SUBJECT: DAVIS-BESSE NUCLEAR POWER STATION, UNIT 1: FINAL ACCIDENT SEQUENCE PRECURSOR ANALYSIS OF FEBRUARY 2002 OPERATIONAL CONDITION

Final Precursor Analysis

Davis-Besse	Cracking of Control Rod Drive Mechanism Nozzles and Reactor Pressure Vessel Head Degradation, Potential Clogging of the Emergency Sump, and Potential Degradation of High Pressure Injection Pumps	
Event Date February 2002	LERs 346/02-002, 346/02-005, and 346/03-002	) CDP = 6 x 10^{-3}

RESPONSE TO COMMENTS

Figure 2. Medium LOCA Event Tree

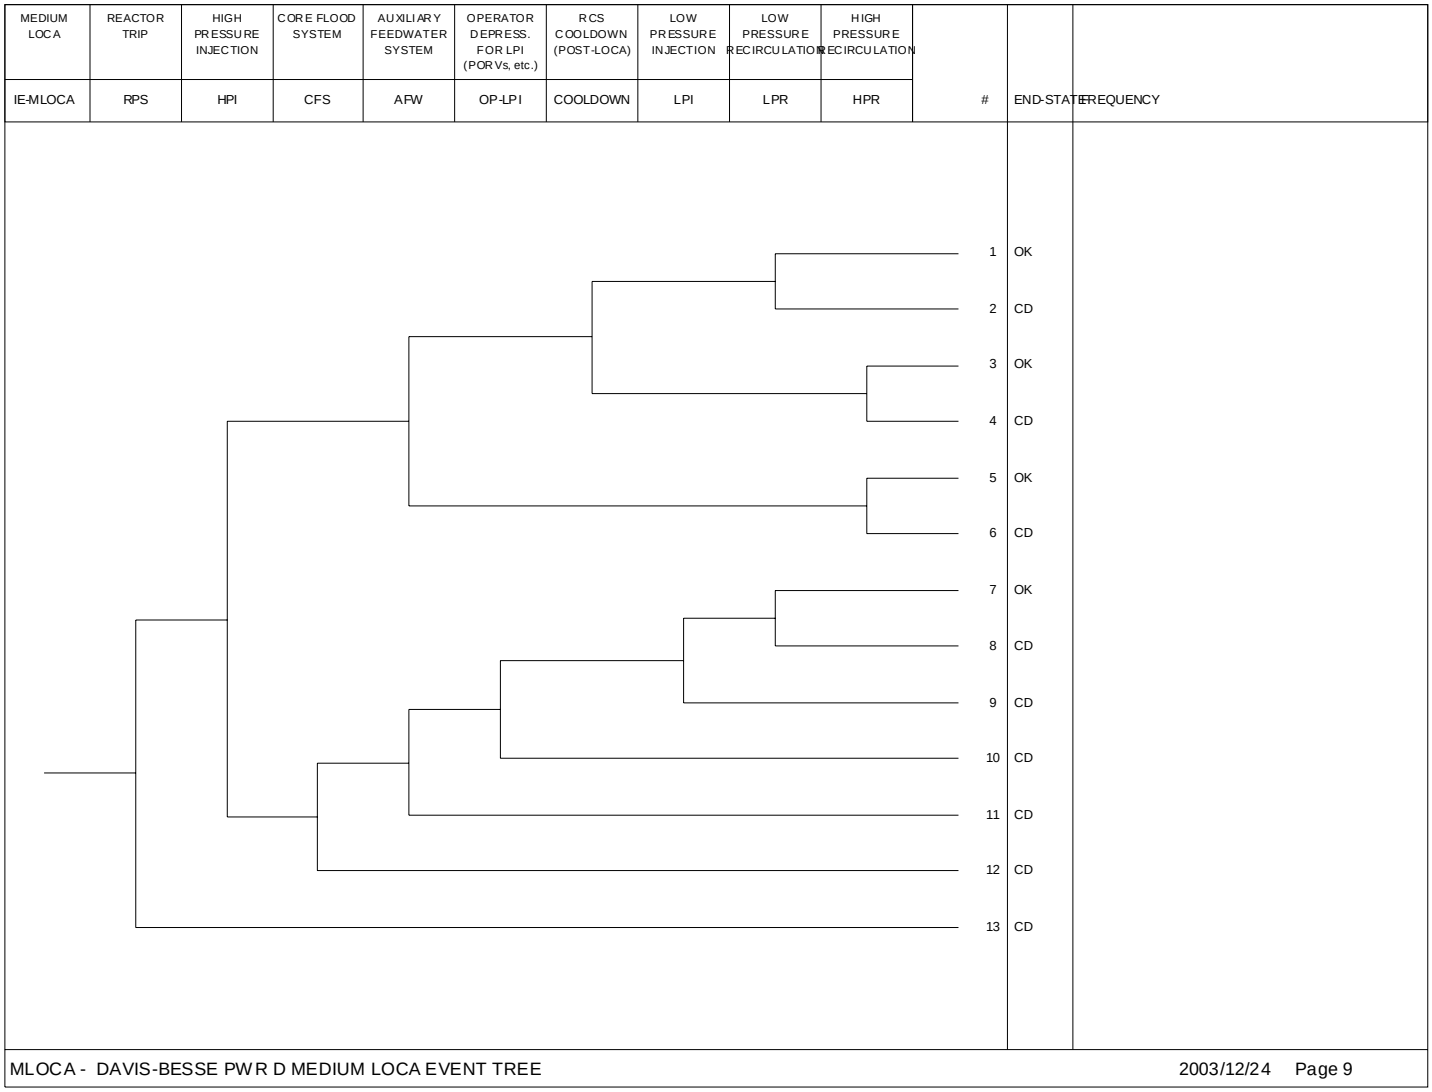
2. The event tree for medium LOCAs (Figure 2 on page 18) includes top events for auxiliary feedwater (AFW) and for cool down of the RCS. The implications of success for these events in the analysis include the following:

There may be conservatism in the PSA and SDP with respect to the ability to avoid core damage in the event of a medium LOCA without HPI available. For the precursor assessment, however, a more significant impact is the assumption that active cool down would be needed to affect LPR in the long term. The expected response following a medium LOCA would be for the RCS to depressurize sufficiently such that, at the time of depletion of the borated water storage tank (BWST), LPR would be established.

If this change were to be made to the precursor analysis, medium LOCA sequence 4 would no longer be a core-damage sequence. This sequence comprises the second largest contribution to the CCDP, according to Table 1 and Table 3B of the preliminary precursor report. Removing this sequence would change the CCDP from 6.2E-3 to approximately 5.3E-3, and would reduce the importance from 6.1E-3 to approximately 4.4E-3.

Response: Changes to the event tree were considered, but do not appear to be justified. The SPAR models for all B&W plants require active heat removal prior to entering LPR. We have no information that proves that using HPI until the criteria for shifting to recirculation are met will always result in the plant being depressurized. In order to justify the change to the event tree, the licensee would have to prove that operators would <u>never</u> use HPR following a MLOCA.

The RCS cool down top-event (COOLDOWN) is included in sequences in which AFW is successful. The dominant event in the COOLDOWN fault tree is the operator failing to cool down the plant to LPR pressure. The cutsets and accident sequences that credit depressurization following failure of HPR are realistic, based on our understanding of plant procedures and response.
